APPLICATION FOR WITHHOLDING PROPRIETARY  
INFORMATION FROM PUBLIC DISCLOSURE

SUBJECT: "Fuel Rod Bow Evaluation", WCAP-8691, Revision 1 (Proprietary)

REF: Westinghouse Letter No. NS-EPR-2572, Rahe to Miller dated  
March 16, 1982

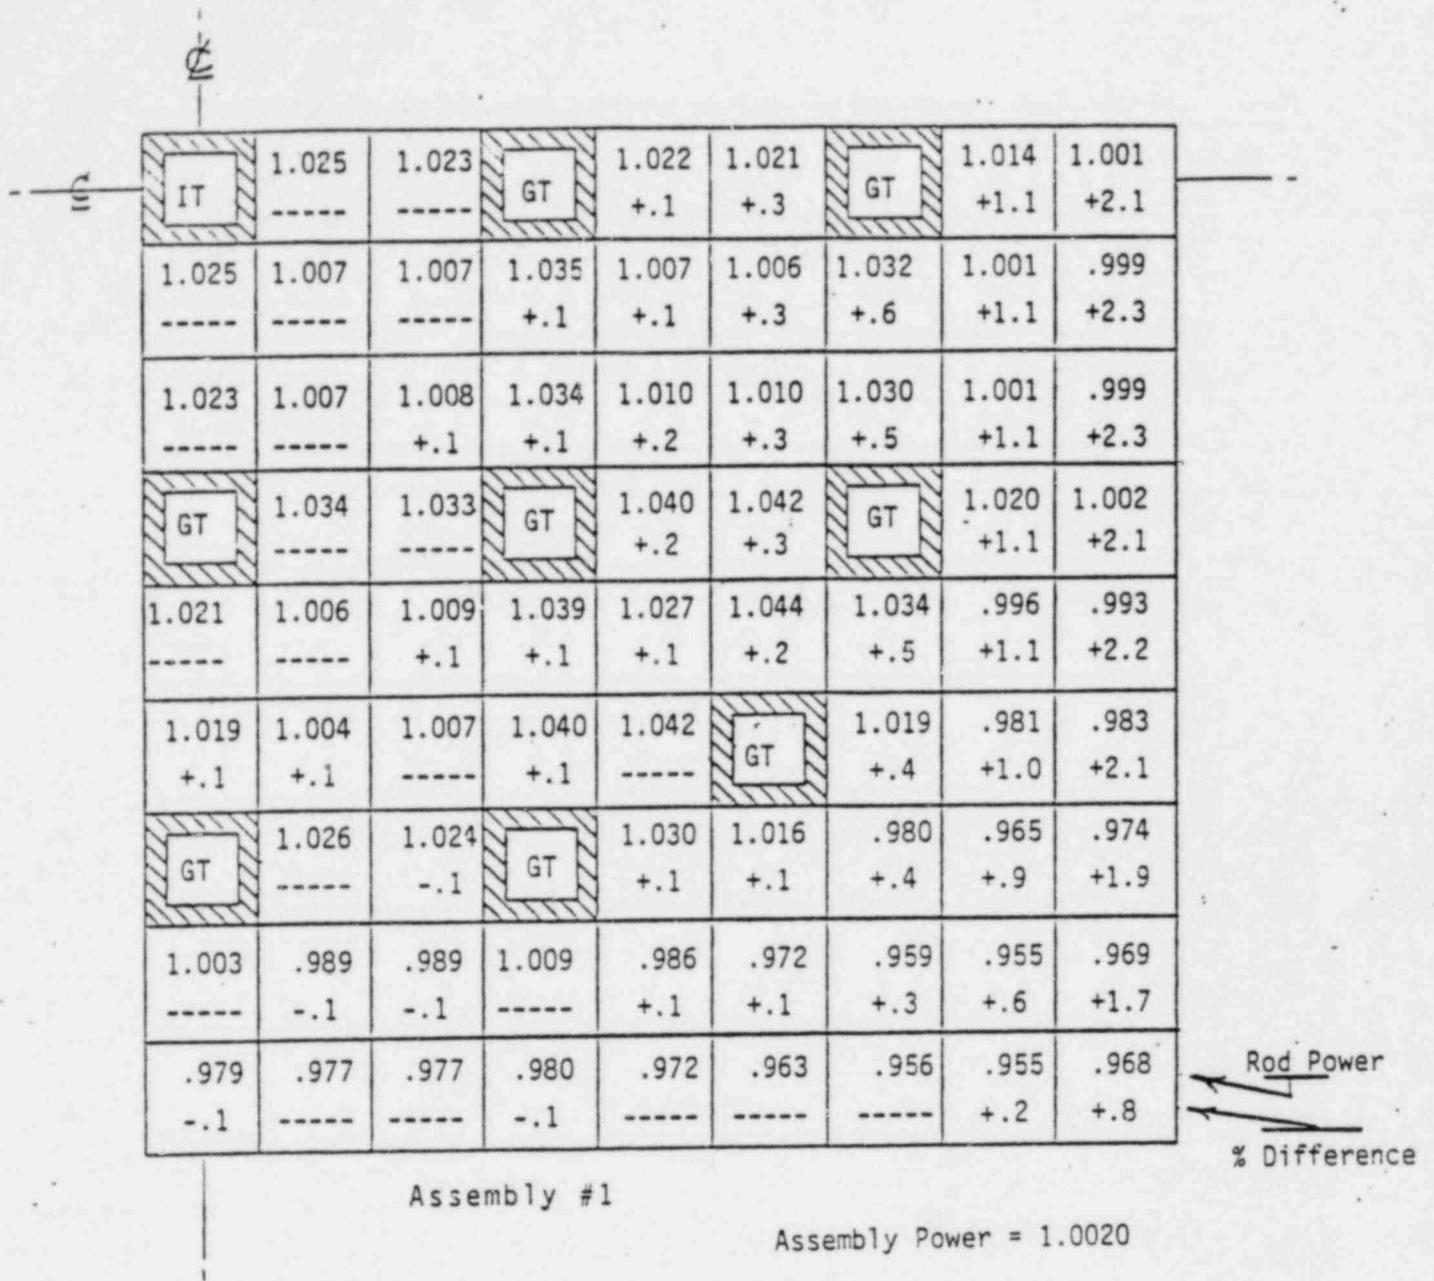
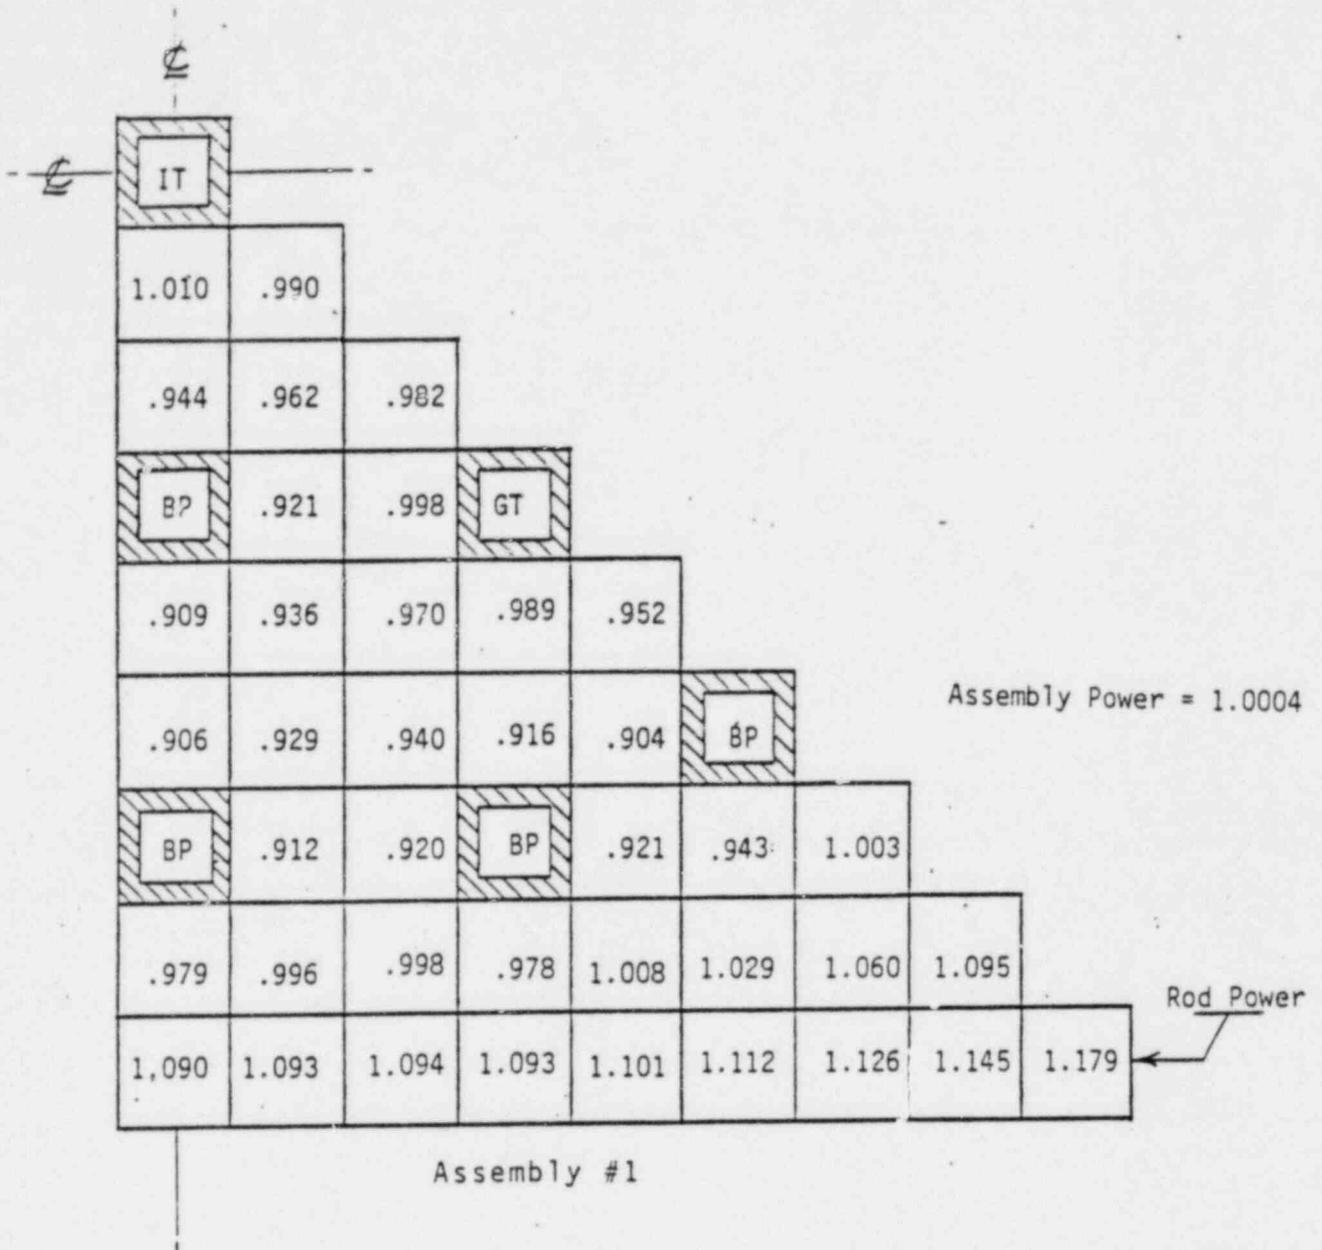
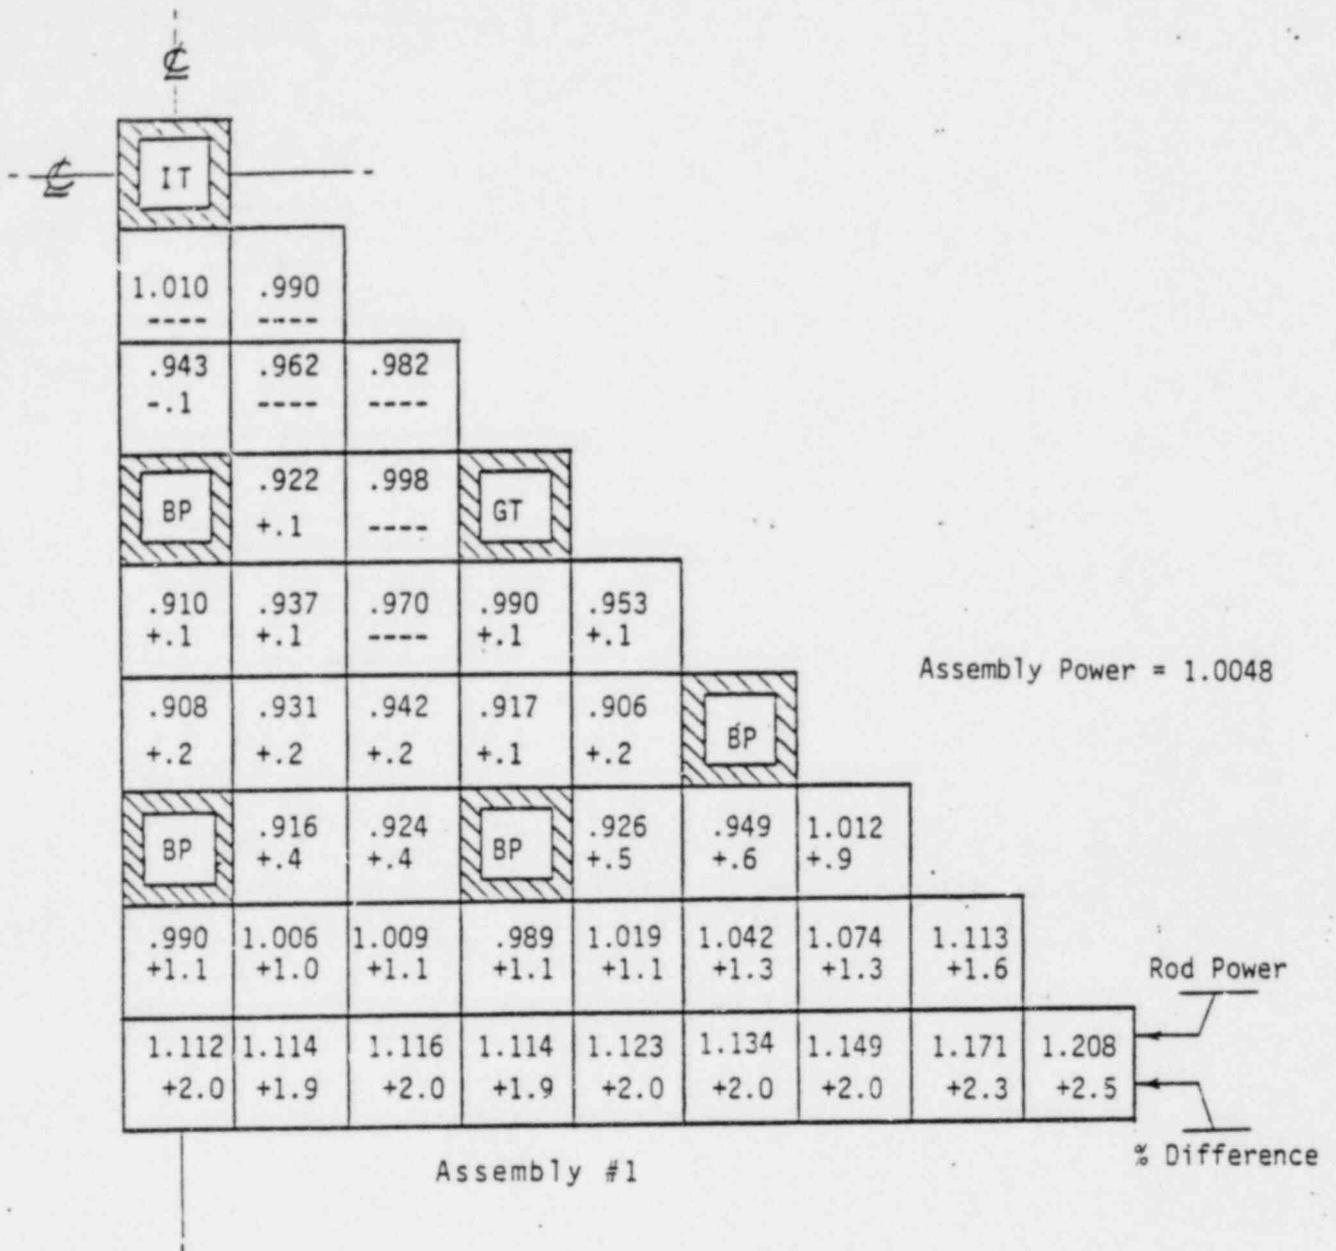
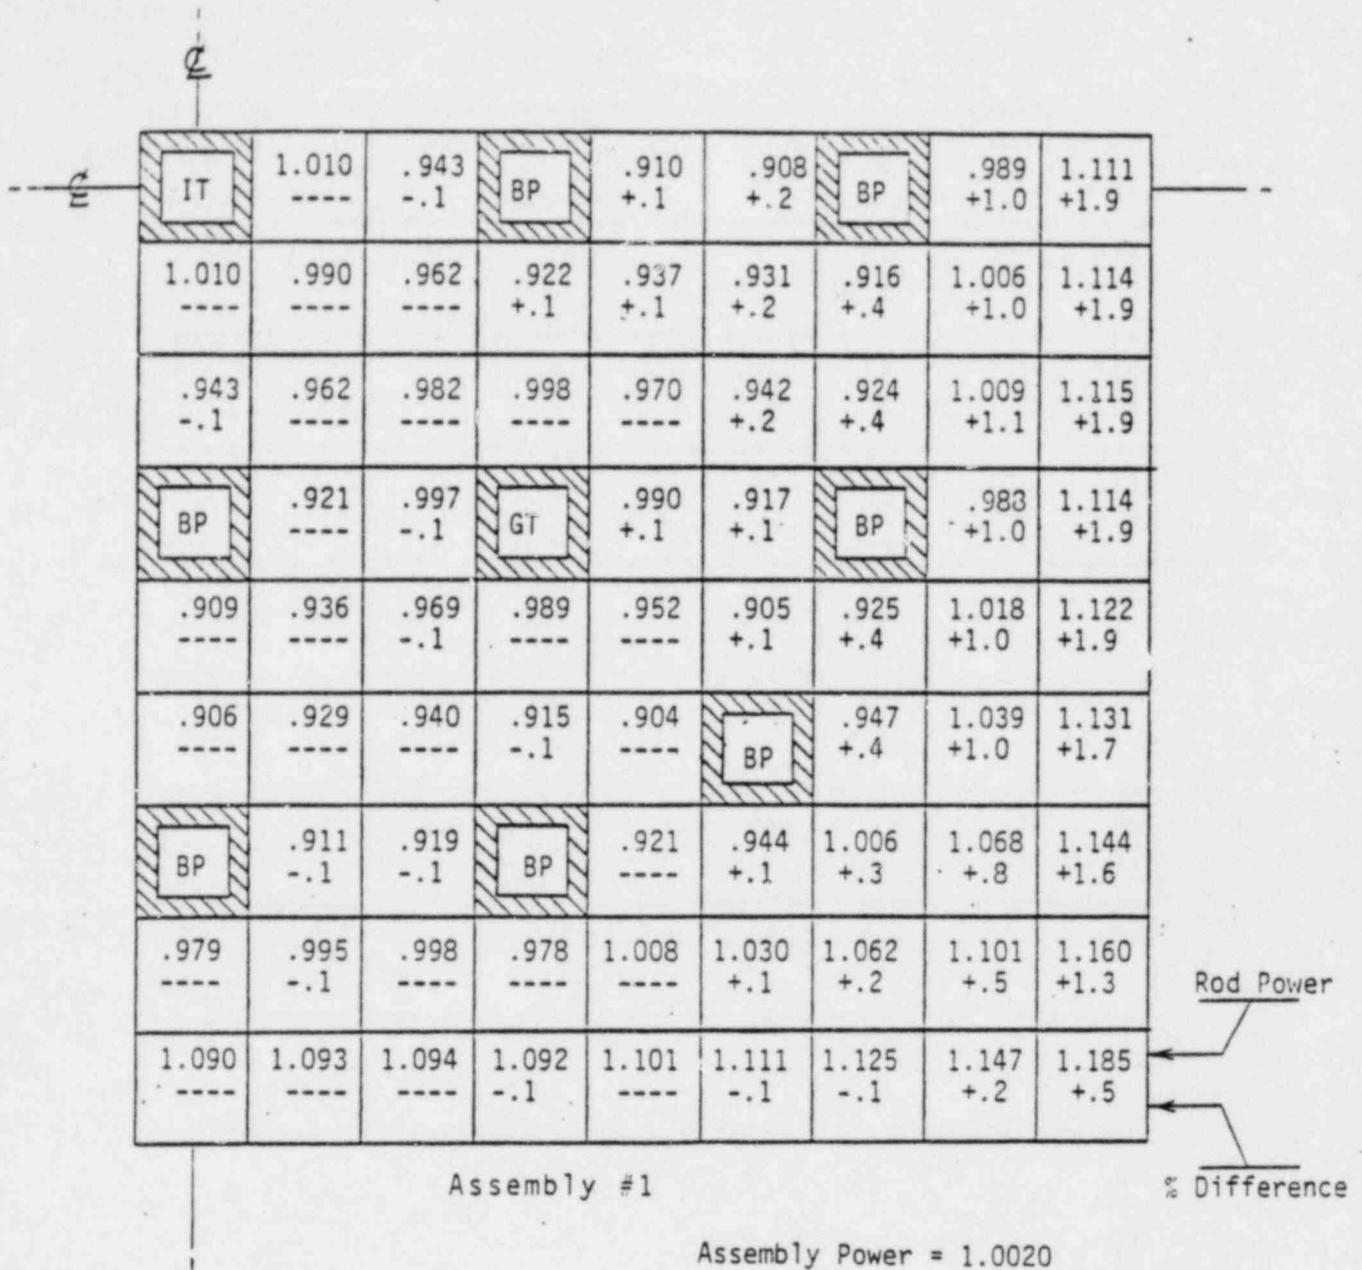
QUESTION 36: Large assembly bow on the order of hundred of mils has recently been measured at several plants.<sup>2),3),4)</sup> This bow is of concern because (1) the bow magnitude is at least an order of magnitude larger than the reported rod bow measurements, (2) the resulting rod bow is apparently extremely correlated with all rods in an assembly face bowing together, and (3) the bow involves inter-assembly gap closure. All of these aspects are outside the scope of the proposed bowing analysis. Therefore, discuss in detail the effects of assembly bow on fuel rod gap closure and the assumptions and methods used to evaluate rod bowing.

Accordingly, two typical 17x17 4-loop first core arrangements of four fuel assemblies were modelled. This 2x2 mini-core modelling was done using TURTLE, the standard two-dimensional, two-group diffusion theory design code, in an atypical fashion to simulate asymmetric gap increases and decreases. The first 2x2 mini-core was comprised of four 3.1 w/o assemblies containing no burnable poisons. Figure 1 shows this arrangement with nominal gaps ( $\sim 40$  mils). The peak rod is near the water hole with a relative power of 1.042. The corner rod has a rod power of .960. Figure 2 shows this arrangement with the two adjacent gaps increased to 80 mils. (Assembly gaps of 80 mils represent at least one adjacent assembly bowing away to closure.) Note that the corner rod power has increased  $\sim 3\%$ , the assembly power by  $\sim .5\%$  but the peak rod by only .3%. Figure 3 shows the situation in which one gap has increased to 80 mils but another one has decreased to closure. Note that again the assembly power and peak rod power has changed only slightly.

The second 2x2 mini-core was comprised of one 3.1 w/o, 20 BP assembly, two 2.10 w/o, no BP assembly, and one 2.6 w/o, 16 BP assembly. This is a typical 4-loop, 17x17 first core enrichment, burnable poison loading mixture. The geometries depicted in Figure 4 through 6 are the same as those shown in Figures 1 through 3 respectively. In this arrangement, however, the peak rod was a corner rod in the 3.1 w/o assembly for the unperturbed configuration (Figure 4). When two gaps

increased to 80 mils, the peak rod power increased 2.6% while the overall assembly power increased  $\sim 0.5\%$  (Figure 5). For the other case, the peak rod increase was less than .6% and the assembly power increase was less than 0.2% (Figure 6).

Although calculated for particular fuel arrangements of 17x17 fuel assemblies, both mini-cores showed very similar rod power increases and decreases for the same rod positions. Thus, it is expected that these results should be representative for all fuel types and configurations in which inter-assembly gaps are off-nominal.
